#### **Planning Commission Vote Report**

Meeting Date: March 12, 2018

Petition: P.Z. 07-2017 Chesterfield Valley Motor Sports (17501 N Outer 40 Rd): A request for

## Preliminary Development Plan

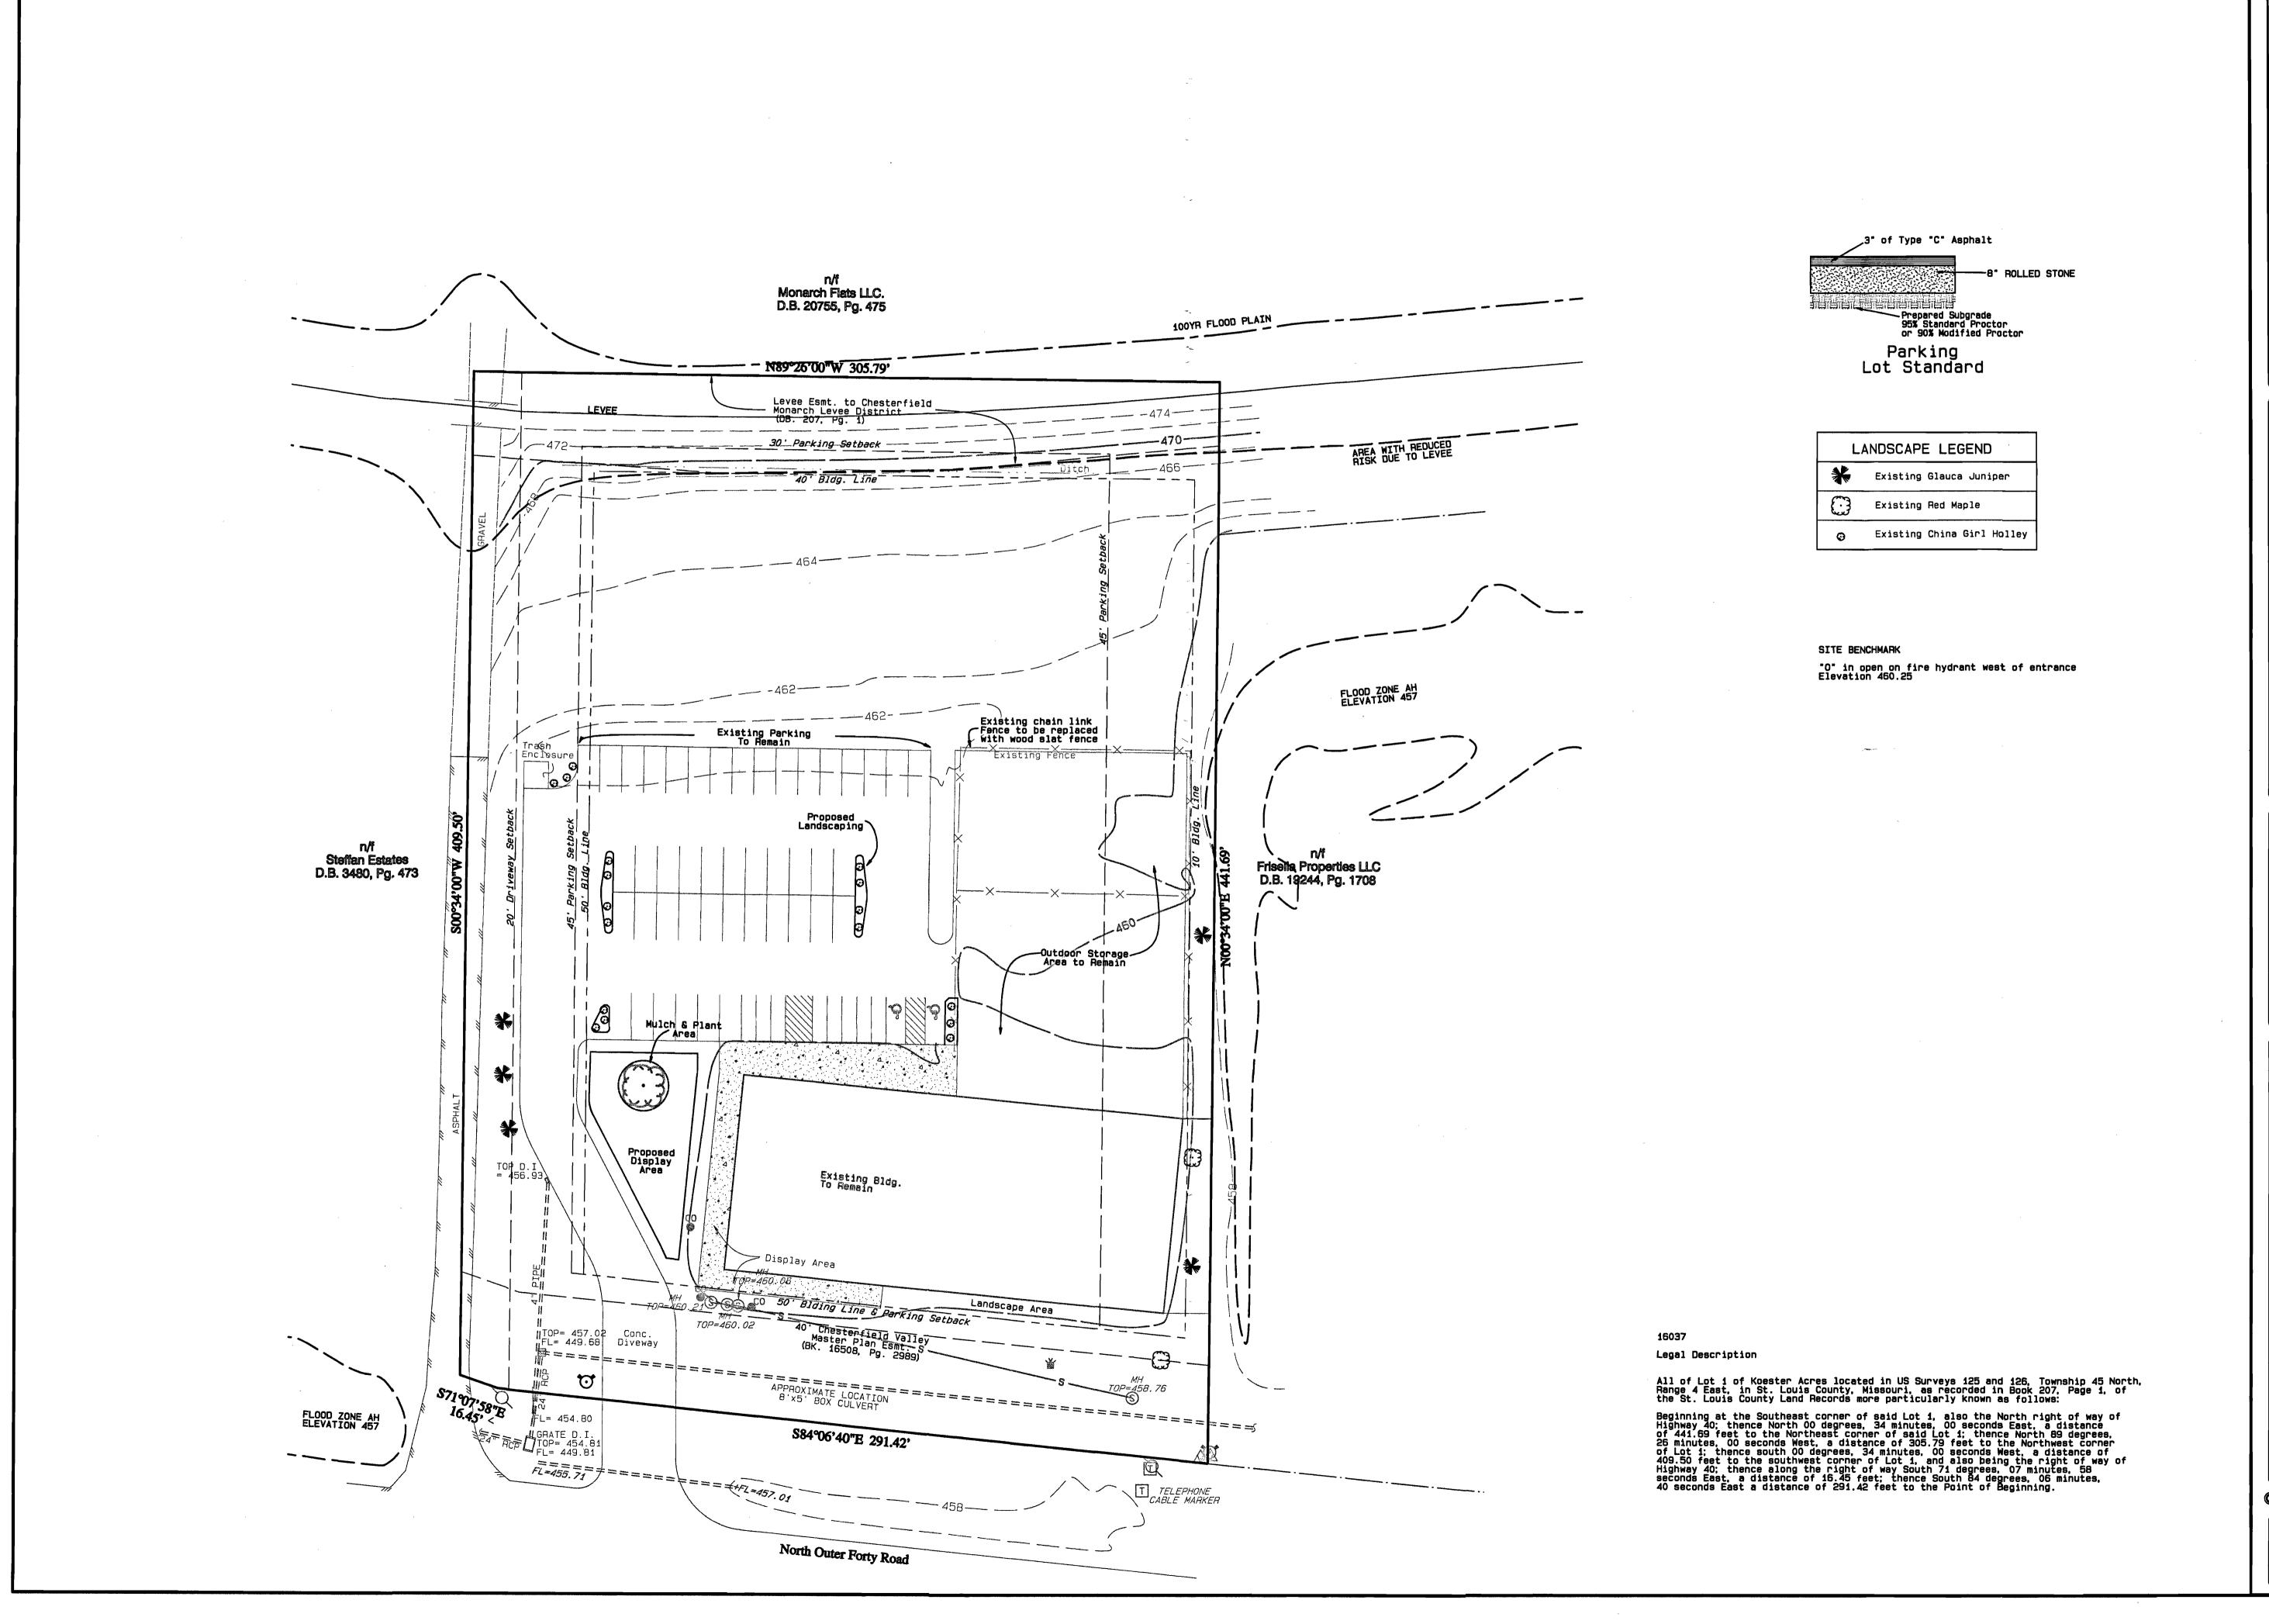
Mr. Surdyke has submitted a request for an ordinance amendment in a "C8" Planned Commercial District. The request seeks to remove the restriction of a maximum of 6 vehicles for the outdoor storage area directly north and west of the existing building. Additionally, the applicant is requesting to expand the outdoor storage area to the northeast of the building by approximately 55 feet as shown on the attached preliminary plan.

- 1. The Commission expressed concern about the type of display proposed. Detail the number of vehicles to be displayed on the sidewalk area of the building, provide the total square footage of display requested, and provide information regarding the type of items requested to be displayed. Requests from the Commission to clarify these items included the following:
  - a. Provide information regarding the construction (mounded boulders, flat pavers, etc) that is proposed for the display area adjacent to the building. Include images illustrating the type of natural display you intend to have in the area next to the building.
  - b. Images of the wrap-around display area depicting examples of the display as desired. With each image, please provide the number of vehicles being displayed.

In addition to the new "proposed" display area we seek permission to utilize the sidewalk area around the building for display. This area is approximately 1500 square feet, currently exists, and has concrete as its surface. The "proposed" display area will have more of a natural look. We propose to use a grass paver system similar to the attached document. This allows the surface to maintain the natural look of grass while being sturdy enough to support the weight of the vehicles and remain dust free and drainage friendly.
